EQUIPMENT UPDATE

Log Number: EU-2-372

Part: MODEL C PAN SUPPORT

Models Affected: MODEL C

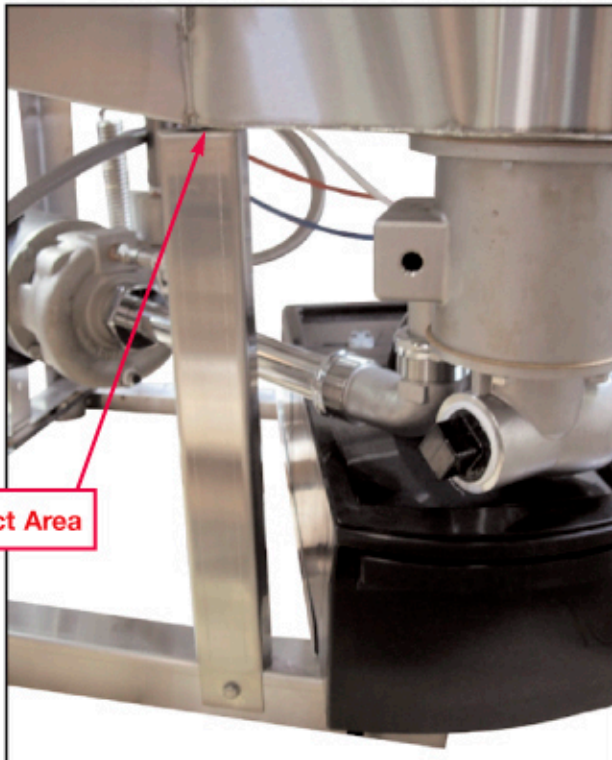
BEFORE

Pan support rests on the underside of pan near the weld. Separation and impact damage sometimes occurs to the welded area during travel and movement by the freight carriers.

AFTER

To prevent transit damage to the welded area, CMA has changed the pan support design to fasten to the side of the pan. We have also repositioned the leg thus eliminating transit force movement to the welded area.
